FIVE KINGDOM STREET

ENVIRONMENTAL STATEMENT
ADDENDUM VOLUME I:
NON-TECHNICAL SUMMARY &
VOLUME II: MAIN TEXT

Addendum to Environmental Statement (CBRE,
April 2019)

British Land

Figure 5.1

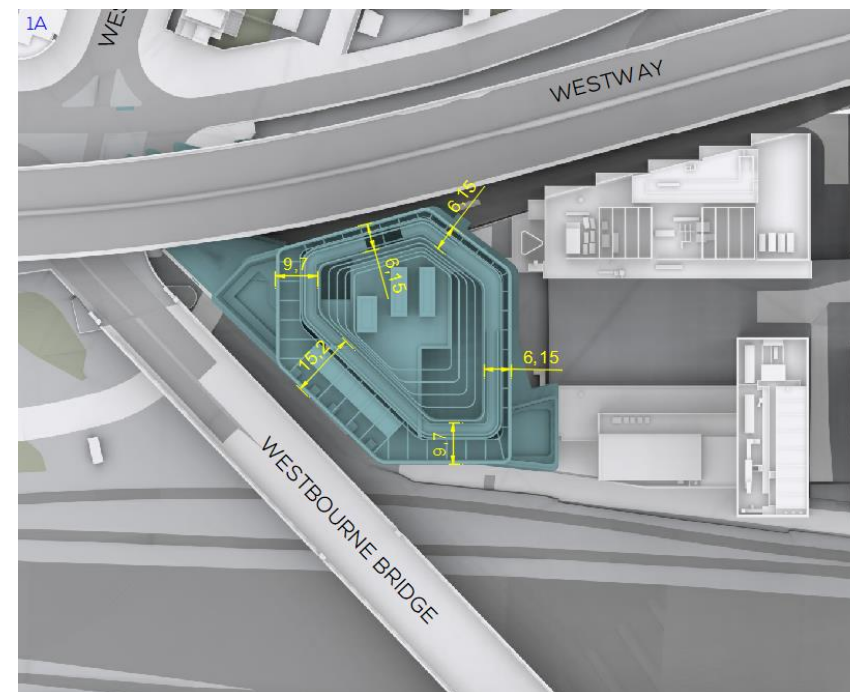
At the ground level, the additional massing is not significant in nature, when compared to the main building massing of the July 2020 amended scheme, which would create the majority of the impact to the neighbouring properties. As such, no additional impact would be caused by the massing change at ground level.

Under the amended scheme, it is understood that increase in height of the lift over-runs and roof plant is 4.32m when compared to the original 2019 scheme. However, the increased massing for the plant at roof level is stepped back from the edge of the main body of the building. The distance from the edge of the building compared with the original 2019 scheme is between 6.15m at the closest point and 15.2m at the furthest, as can be seen in the below image.
